<b>City of Cartersville Historic Preservation Commission COP Application Staff Report</b>
Case: COP23-12

**HPC Meeting – 3-21-23**

Address: 23 Cassville Road  
 Applicant: Michael Tidwell  
 Historic District: Cherokee-Cassville Historic District  
 Zoning: R-20  
 Setbacks: Front= 20, Side= 10

**Brief Description:** Construct a retaining wall along Cassville Rd and a fence and driveway entrance along Milam St.

BOUNDARY RETRACEMENT SURVEY FOR:  
**MICHAEL L. TIDWELL**  
**JUSTINE W. TIDWELL**  
LOT #  
LOCATED IN L.L. 453

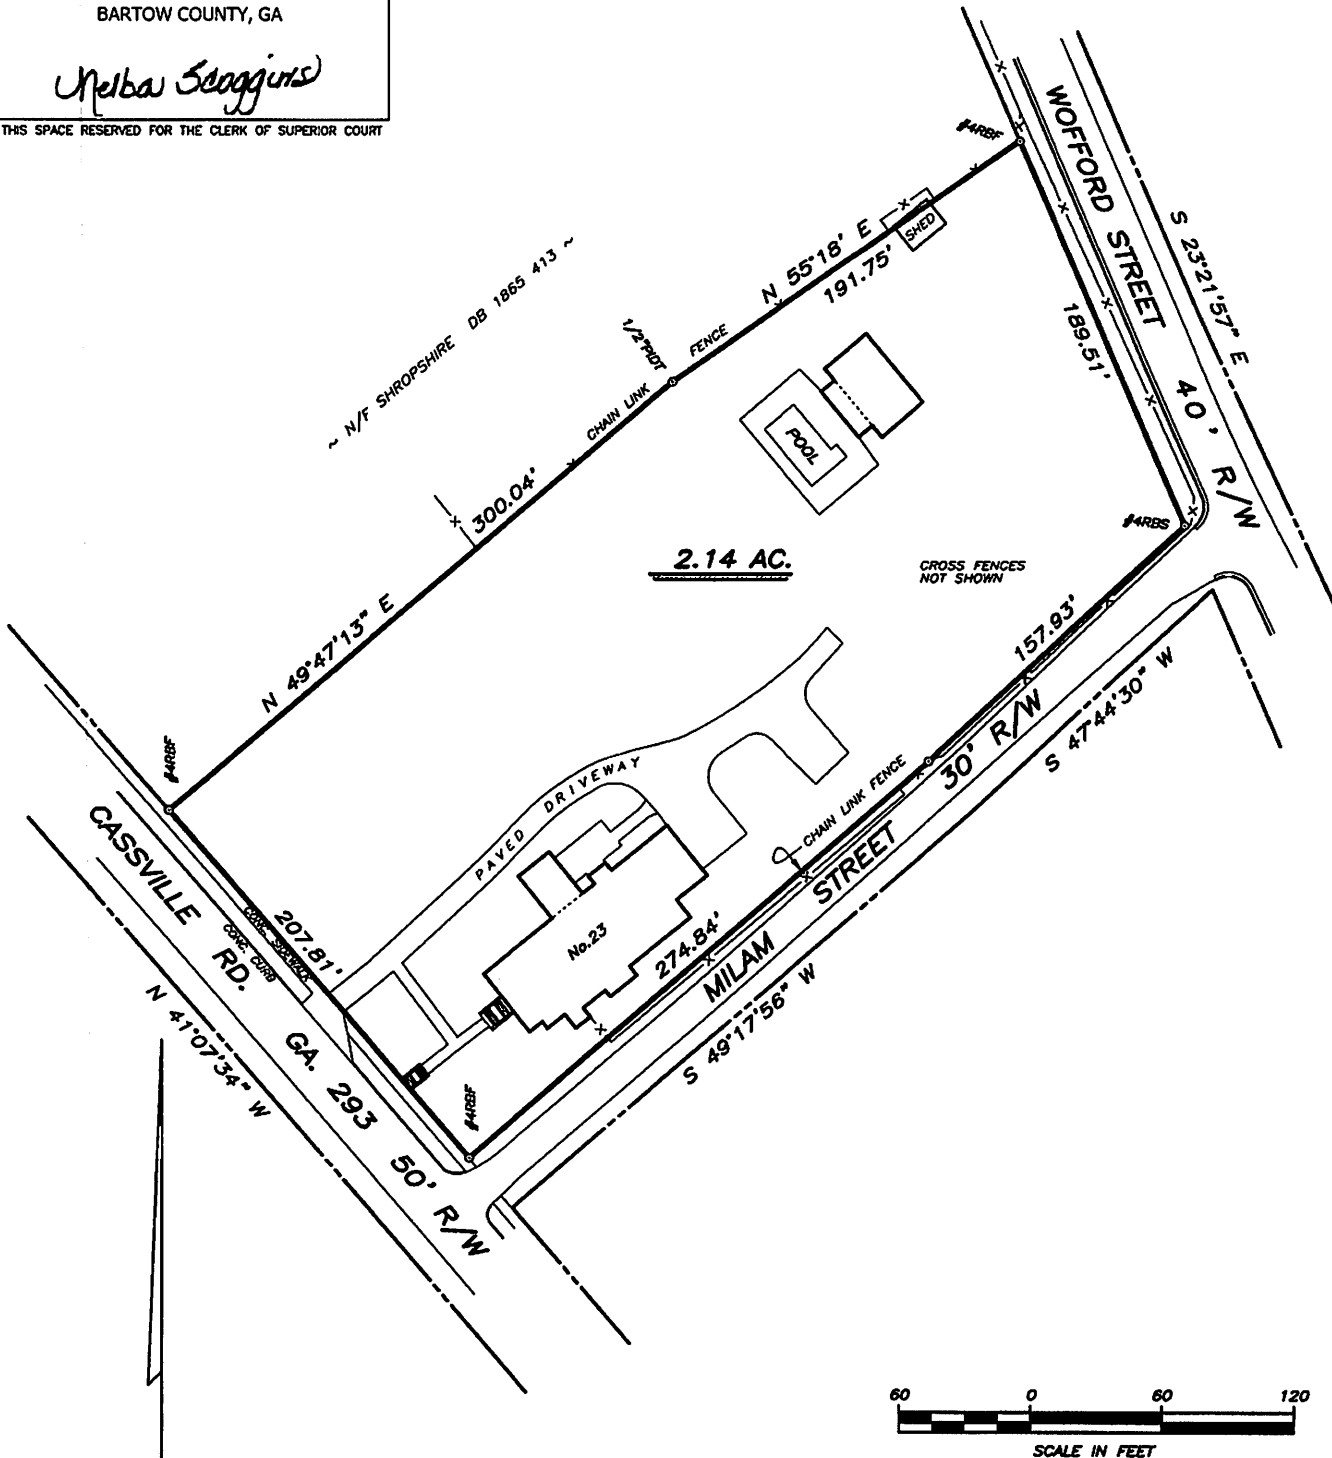
- \* A min. 5ft. concrete apron should be installed where the driveway meets Milam St. if gravel is used for the driveway.
- \* The proposed stone curbing from the driveway to and along Milam St. must be approved by Public Works. Will the curbing affect stormwater flow on Milam St?
- \* All proposed plantings on the Public ROW, other than sod, must be approved by Public Works.
- \* All new fence installations must be installed at or behind the property line. The 2019 property survey shows a portion of the existing chain link fence installed on the public ROW.

TIDWELL RESIDENCE - 23 CASSVILLE RD - CARTERSVILLE, GA.	
SCALE: 1/8" = 1'-0"	APPROVED BY:
DATE: 6-10-19	DRAWN BY: M. GILL
PLANTING & HARDSCAPE ADDITIONS & ALTERATIONS	
M. GILL & FLEMING LANDSCAPES - 404 - 867.5003	REVIS 3-1-23
DRAWING NUMBER	
2 OF 2

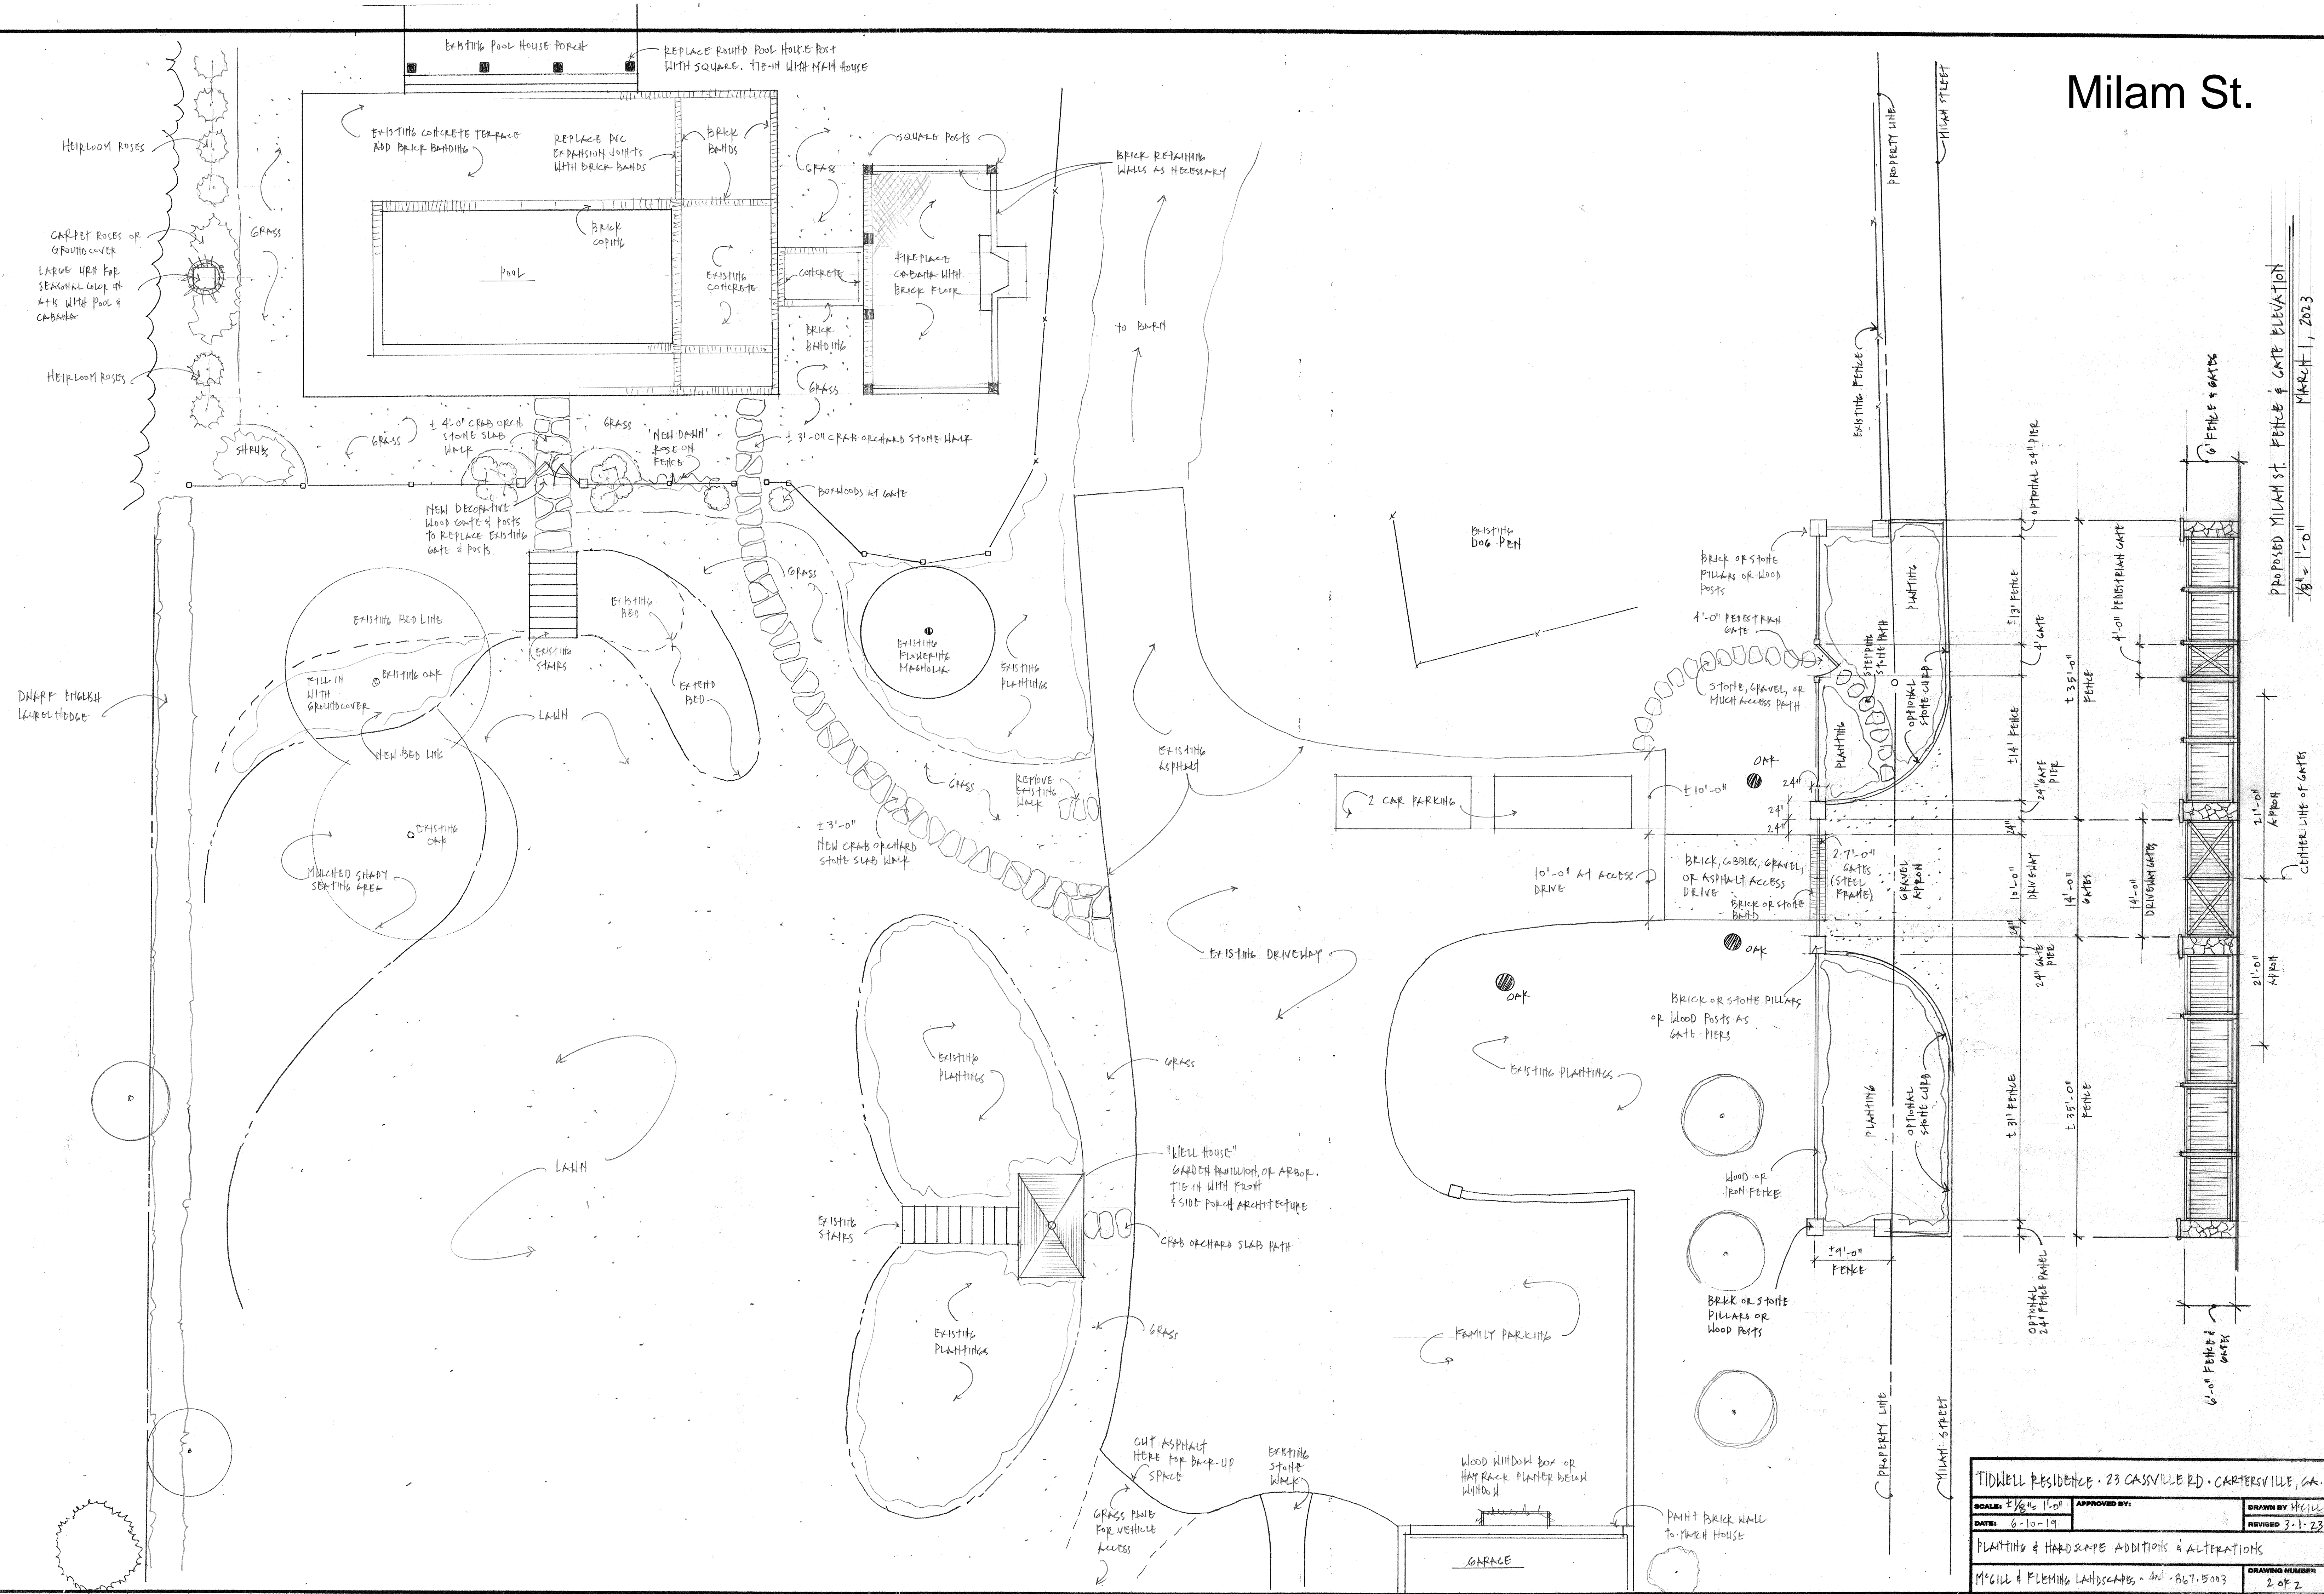
A new gate is proposed for the existing driveway. The gate should be located approx. 20ft. from the edge of pavement to leave adequate room for one (1) car to wait in the driveway for the gate to open/close. Gate style is to be determined. See examples provided.

The gate should be located approx. 20ft. from the edge of pavement to leave adequate room for one (1) car to wait in the driveway for the gate to open/close. Gate style is to be determined. Existing oak trees may interfere with length of driveway apron.

PROPOSED MILAM ST. FENCE & GATE ELEVATION  
 1/8" = 1'-0"  
 MARCH 1, 2023

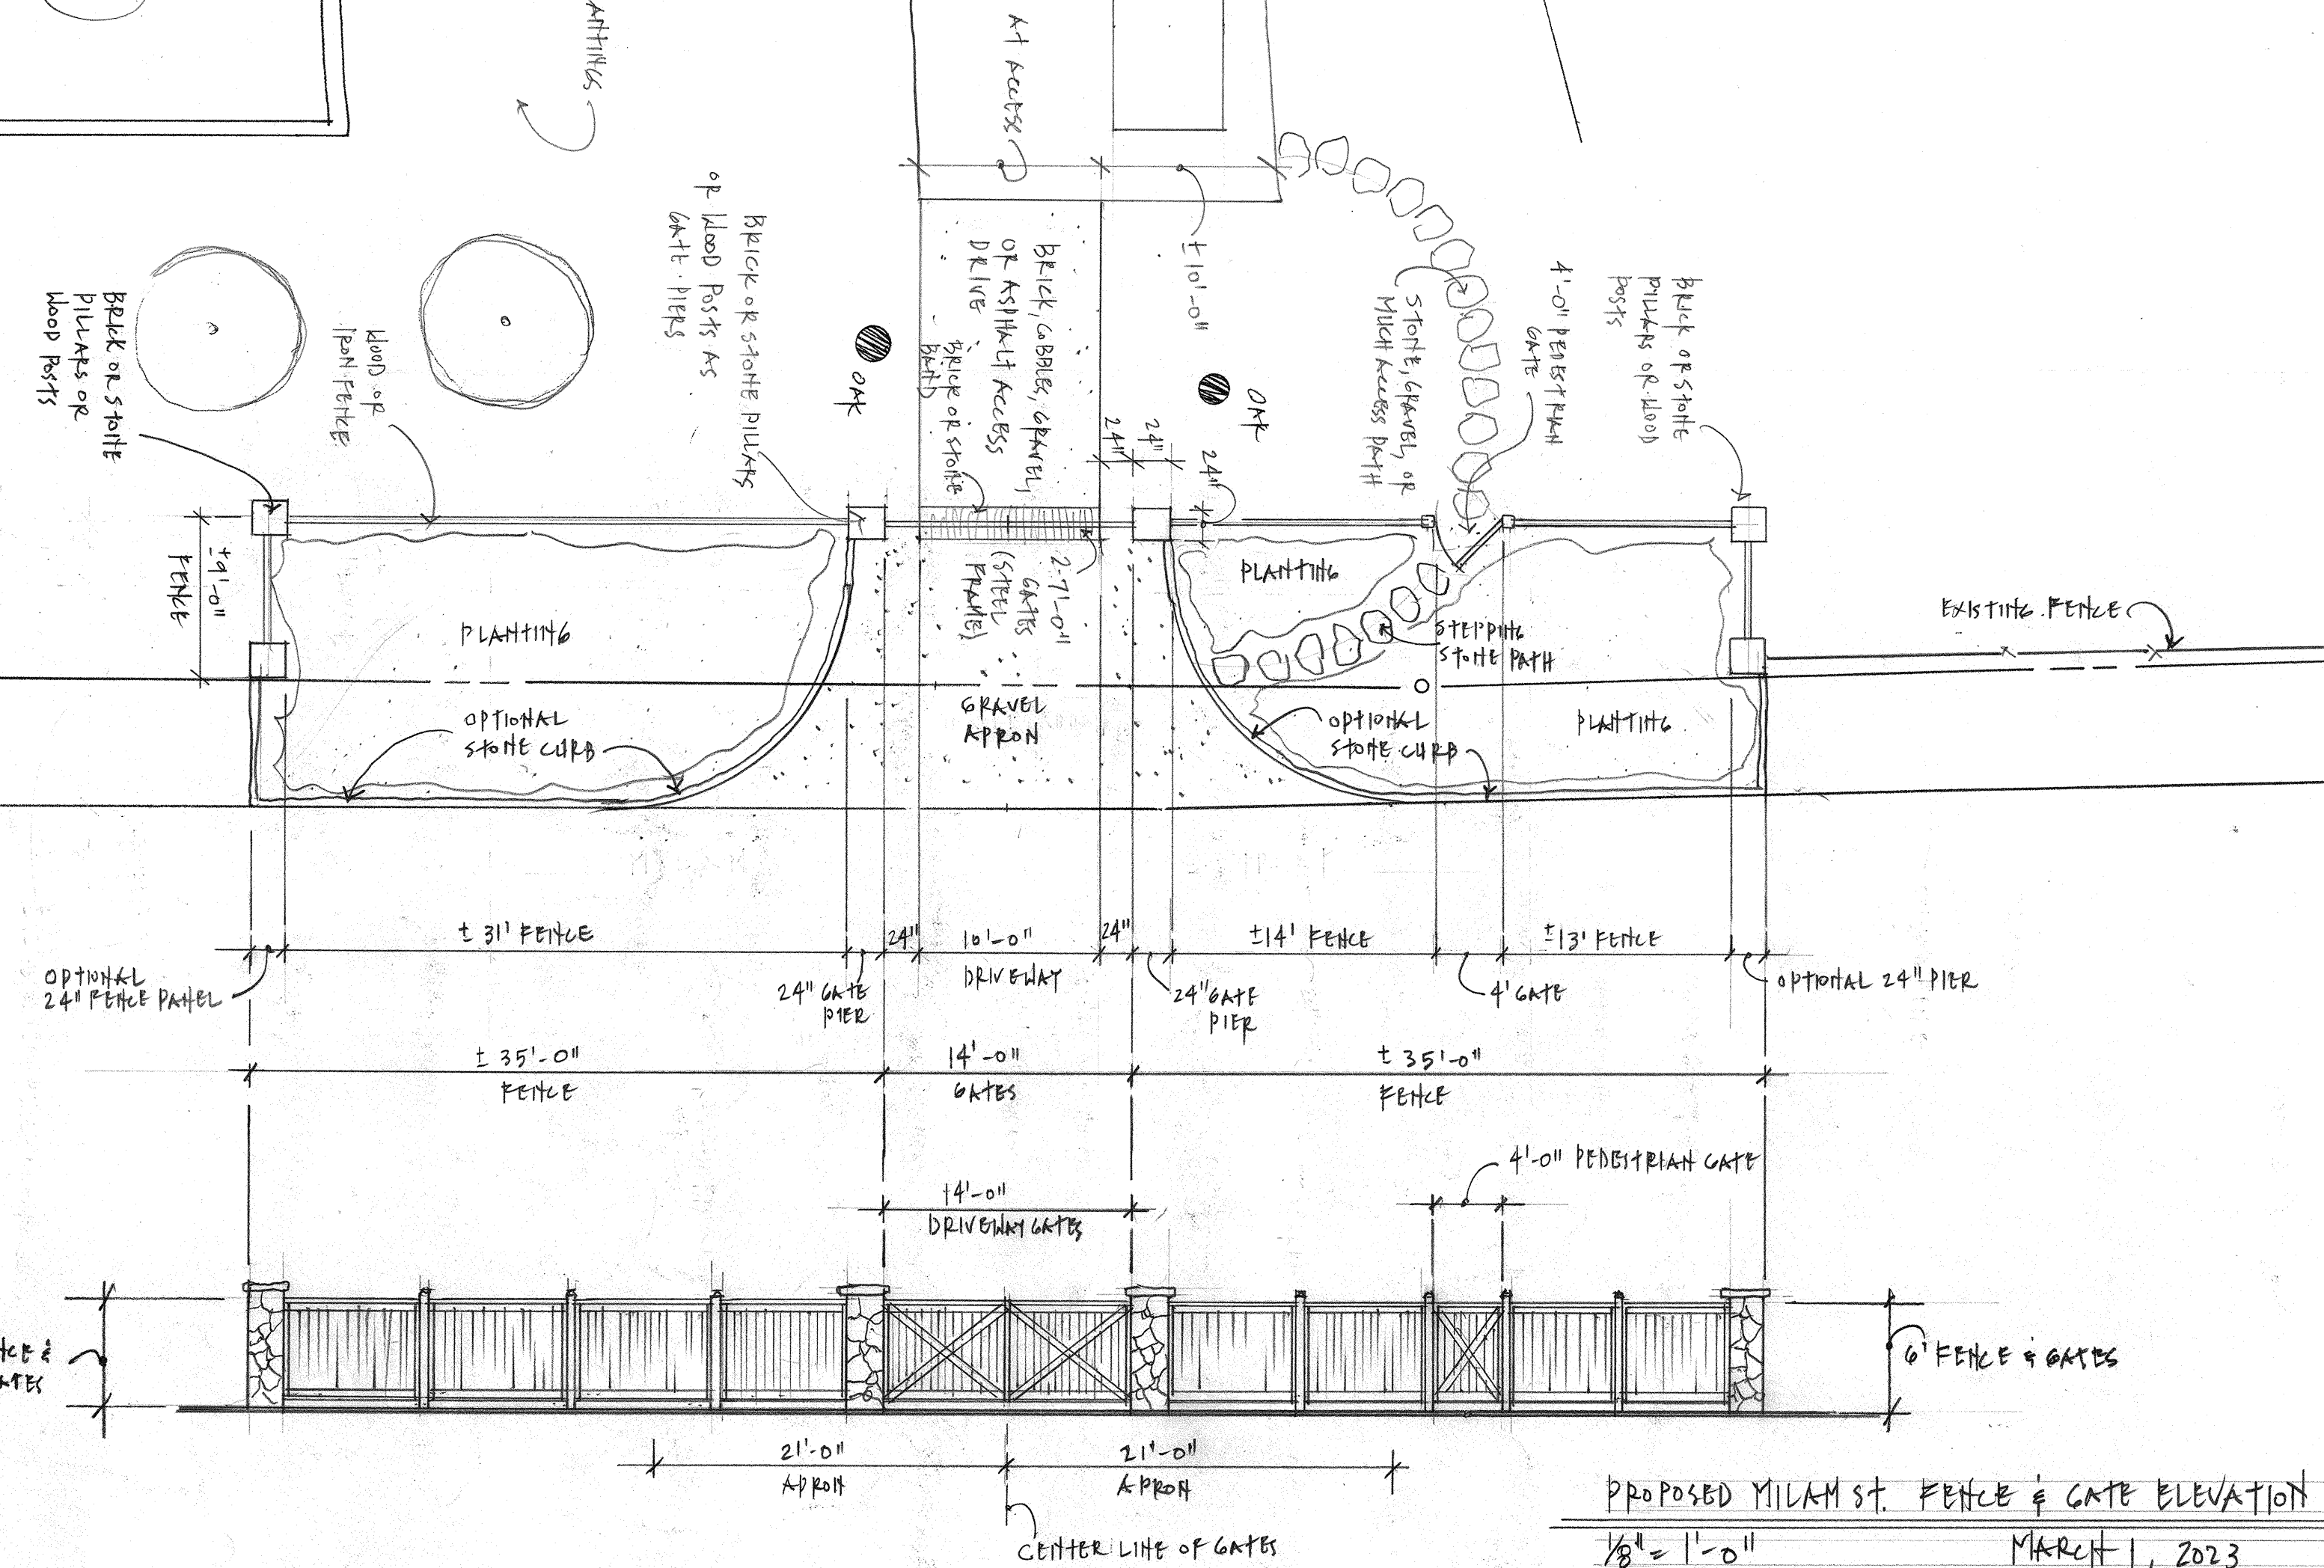
Per a phone call with the applicant, the proposed fence is a 4 rail fence with wire backing like the fence installed at the Milam St. driveway for 15 Cassville Rd. See example provided.
